PROJECT: MAINSTAY SUITES OF ADDISON ADDITION
 BELTLINE ROAD
 ADDISON, TEXAS

SHEET TITLE
 GRADING AND PAVING PLAN

DATE: 09/11/98
 SCALE: 1" = 20'
 DRAWN BY: J.N.M.
 CHECKED BY: JDJR
 SHEET NO. C2 OF 6
 JDJR FILE NO. 98-045

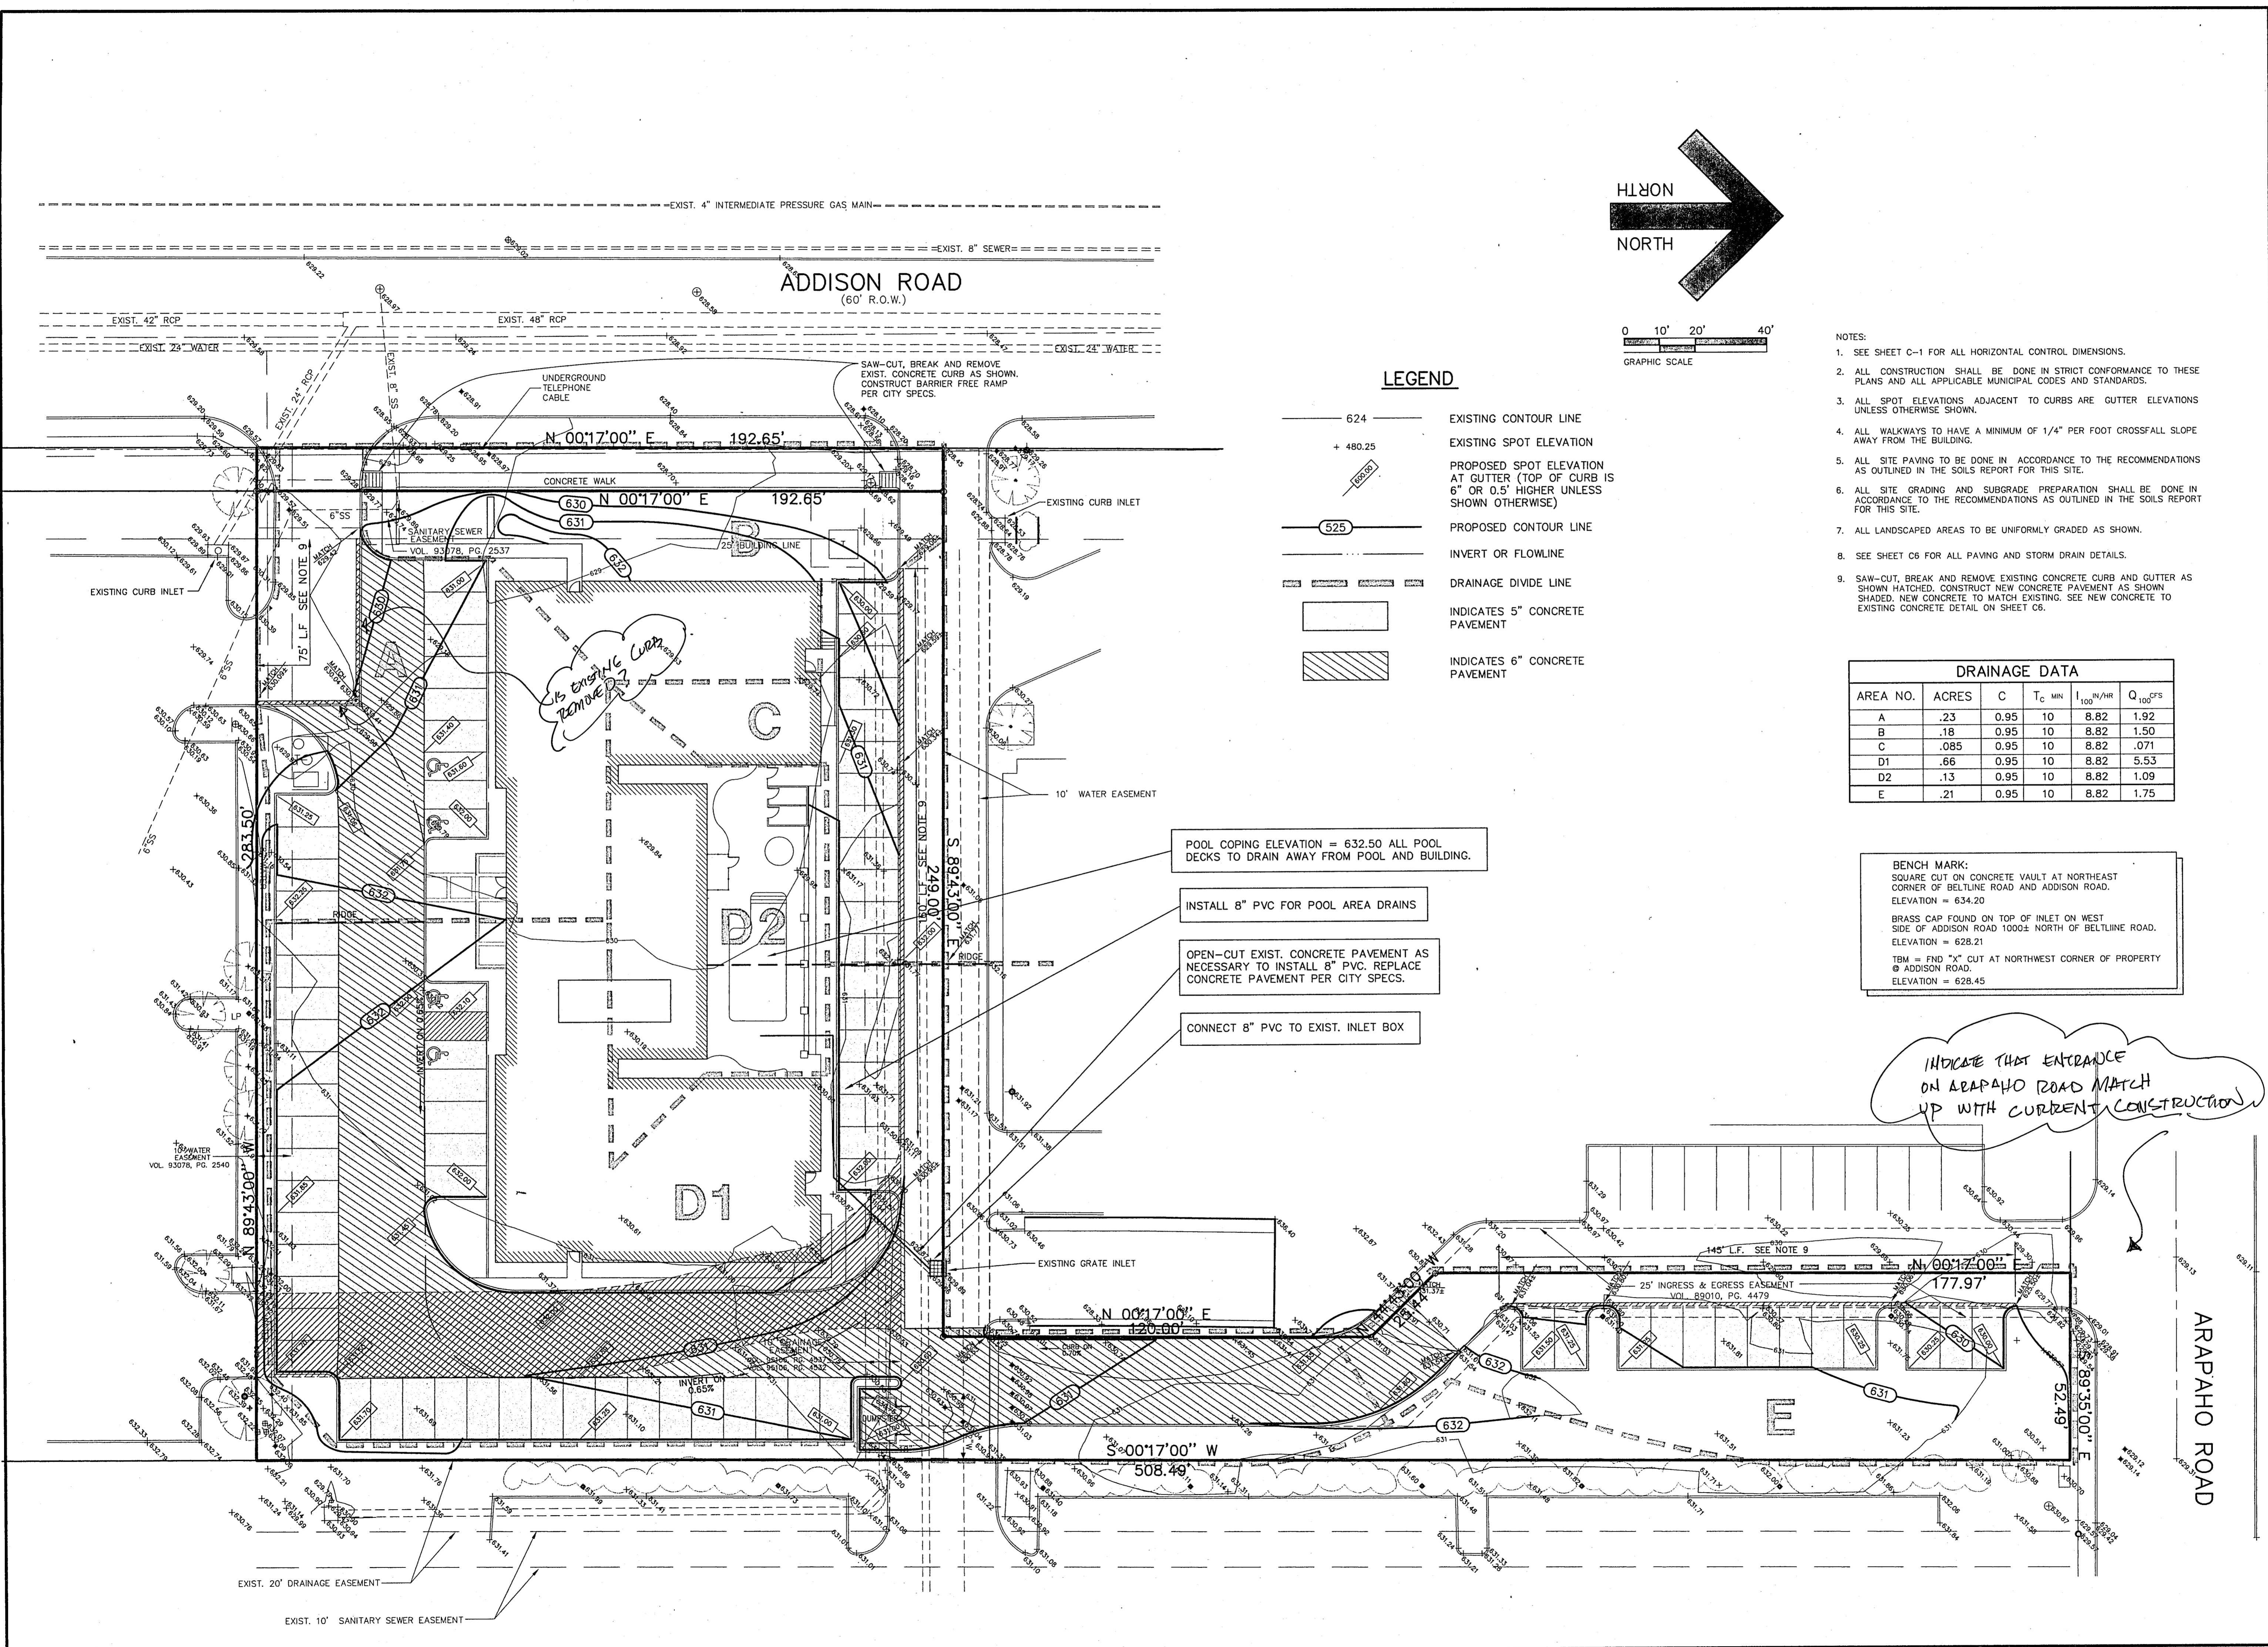
INDICATE THAT ENTRANCE ON ARAPAHO ROAD MATCH UP WITH CURRENT CONSTRUCTION
